**Applicant:** GREEN RIVER HOLDINGS

**Request:** BUILDING PERMIT

**Proposed Land Use:** Metal building shell for warehouse with parking, site lighting and landscaping on property

**4-C-22-TOB  
CERTIFICATE OF APPROPRIATENESS**

L1.1

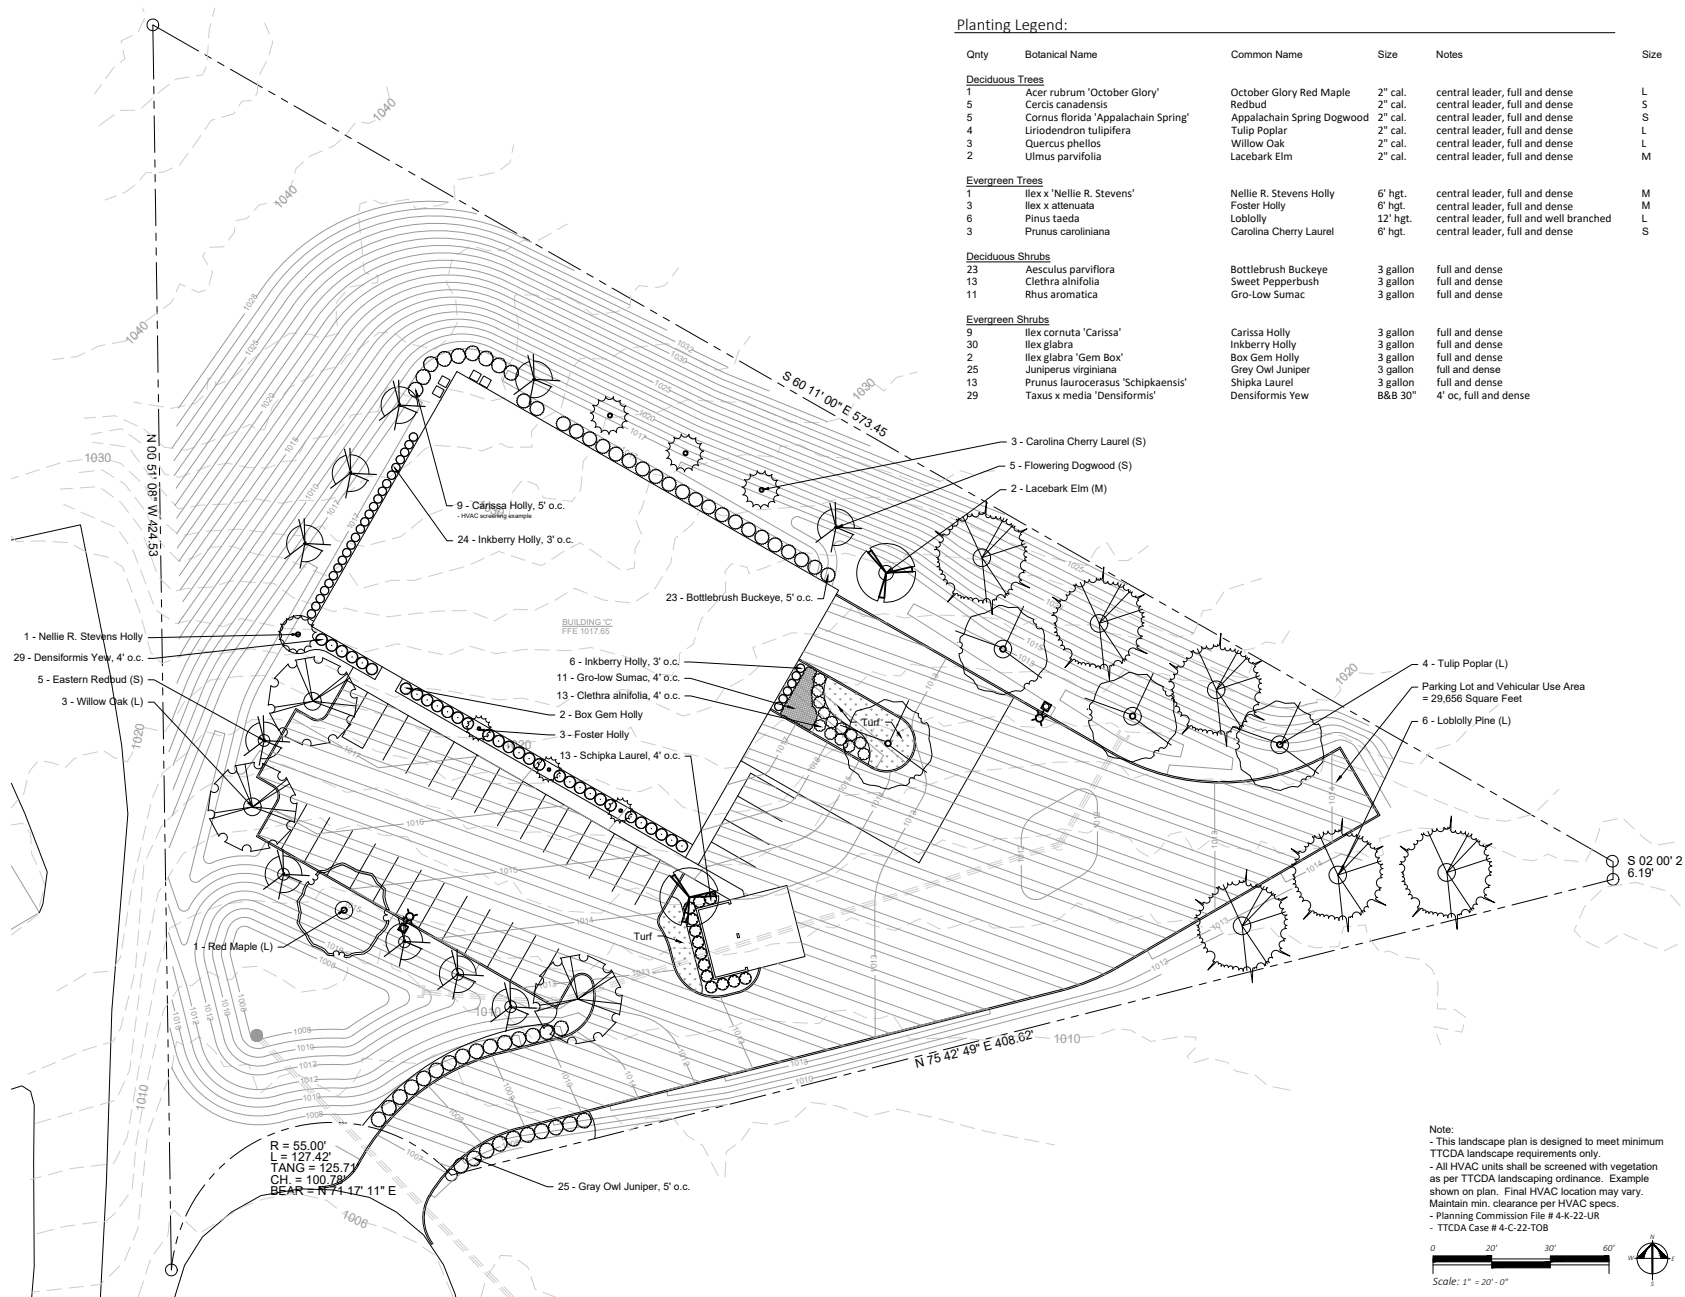
9) The landscape plan meets the landscaping requirements of the TTCDA Guidelines. The Plan proposes plantings along the front foundation of the building and along the edge of the parking lot between the parking and the detention pond. A landscape island separates the loading dock doors, and additional trees are planted around the perimeter of the building. Trees were initially proposed along the right side of the driveway, but a sewer line is located along that lot line, and the utility company has asked that trees not be placed here because the root system could damage the lines. Additional types of plantings, such as shrubs or groundcover, would need to be dug up should there ever be issues with the sewer line; therefore, no plantings are proposed along this side of the driveway.

On behalf of our client, Green River Holdings / S&E Properties, LLC, We hereby request a waiver to the TTCDA guidelines to relocate 4 pine trees along the southern property line in response to Knox Planning forwarded emailed comment from the West Knox Utility District Engineering Department. Apparently there is an existing sewer line that straddles the southern property line. No plantings on top of this sewer line is preferred by West Knox Utility District Engineering Department.

We have relocated the pine trees to the northeast corner of the property, shown in revised Site Plan "C" Landscape Plan L1.0 attached.
